# THE-GREEN SOUTHALL

Design & Access Statement  
Addendum incorporating responses to  
DRP and other consultee comments  
Oct 2021

This document has been prepared as an Addendum to the submitted Design and Access Statement (April 2021).

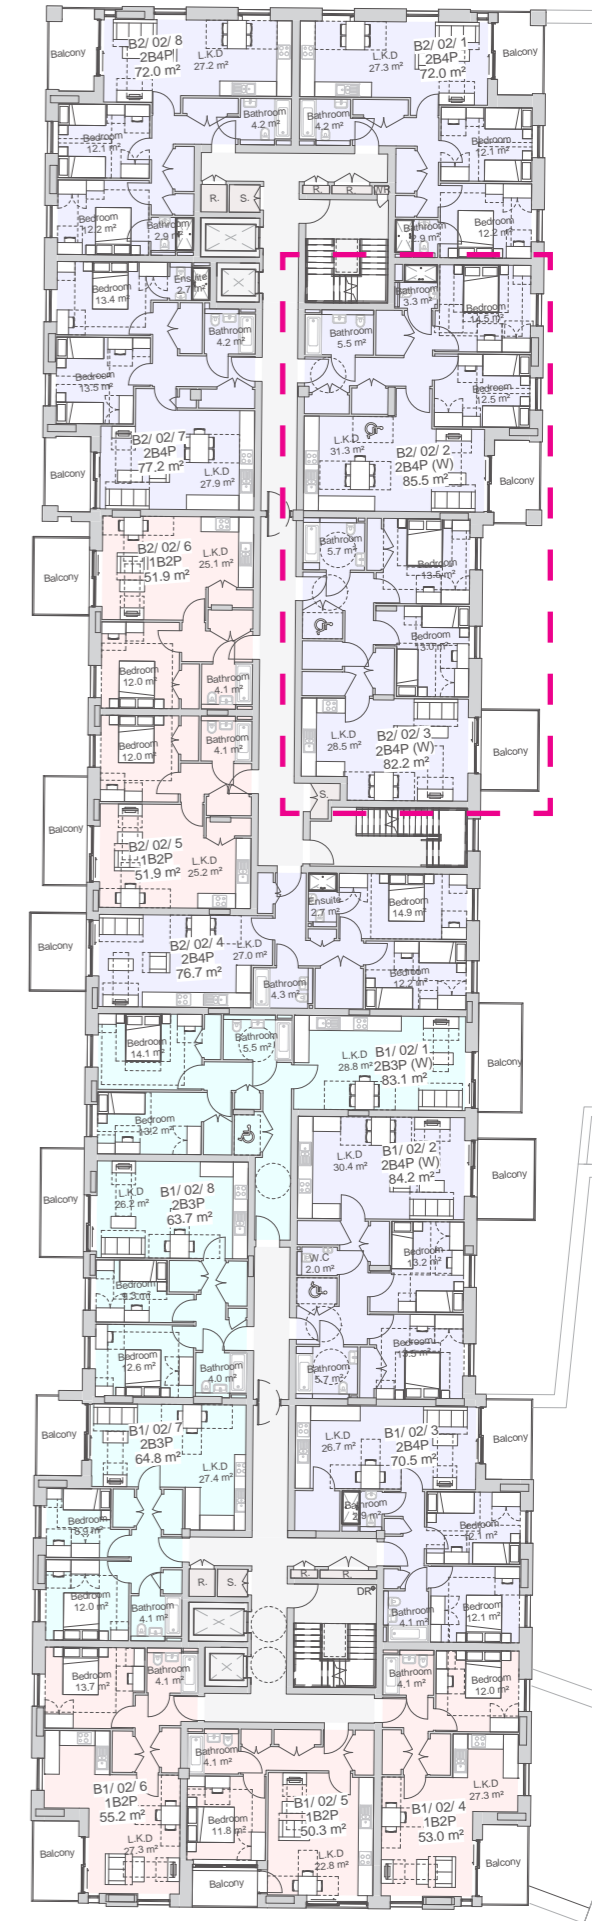
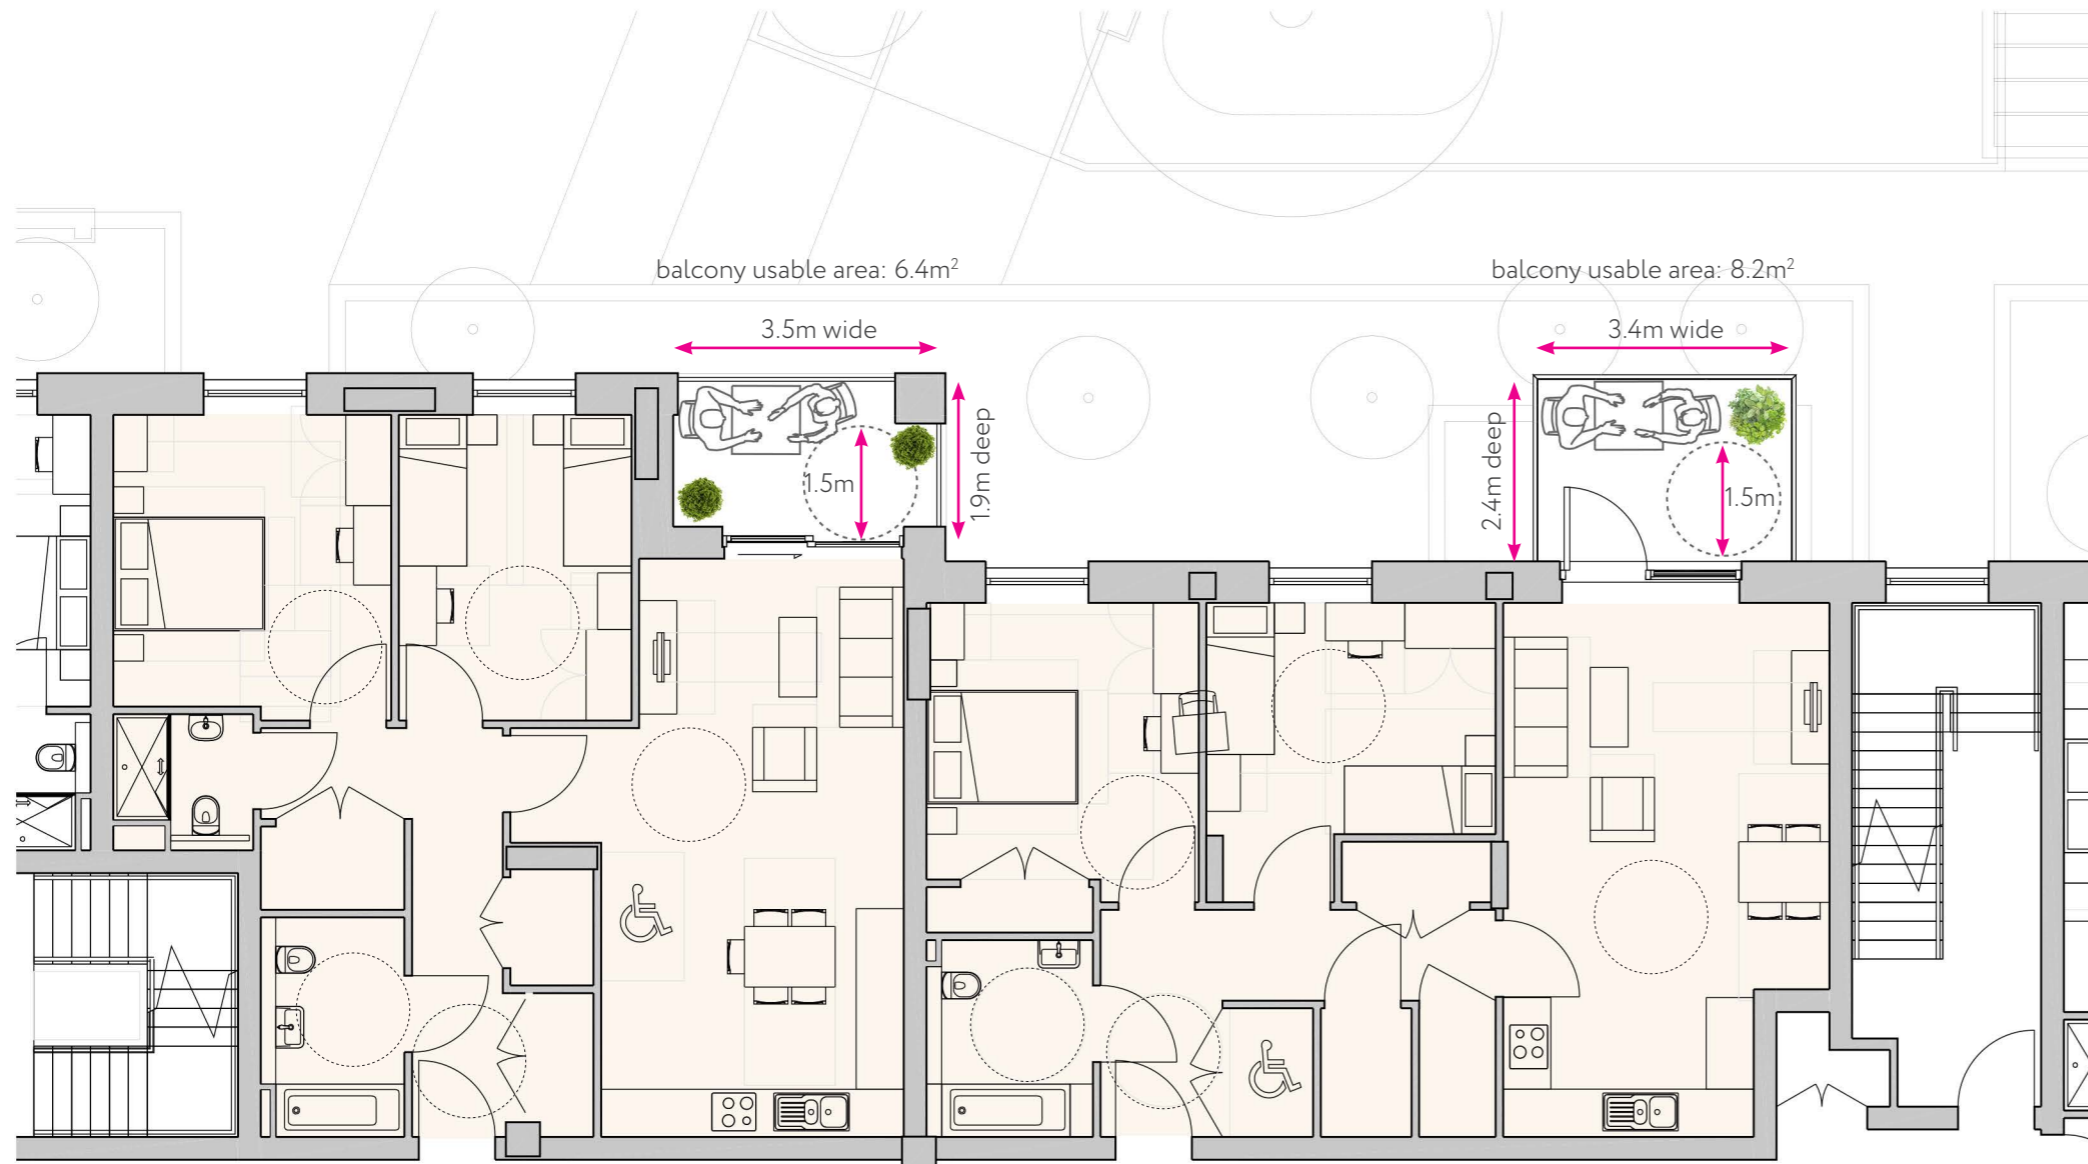
*DRP comments: "The balconies of the accessible residential units should be designed to be large enough to be used comfortably by disabled people."*

The following section incorporates annotated typical layouts of proposed Part M4(3) - Wheelchair user dwellings to illustrate the quality and usability of outdoor private amenity space.
